UNITED STATES PATENT AND TRADEMARK OFFICE

Office Action Summary

10/505,172

NAKATSU ET AL.

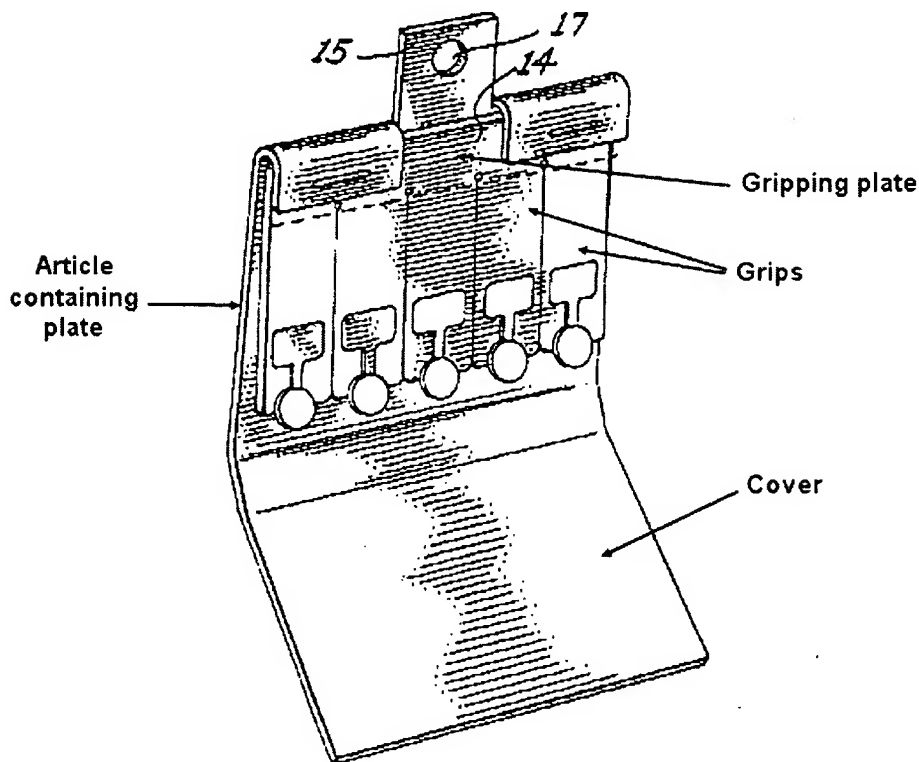
However, Cerny teaches a battery holder comprising a gripping plate (See figure below) hingedly attached to an article containing plate (See figure below), the gripping plate being provided with a plurality of grips (See figure below) configured to hold corresponding articles (batteries) at a distal end, the grips configured to be individually.

separable from each other for the purpose of protecting the articles and allowing a single grip to be separated to ease the installation of the battery into a device.
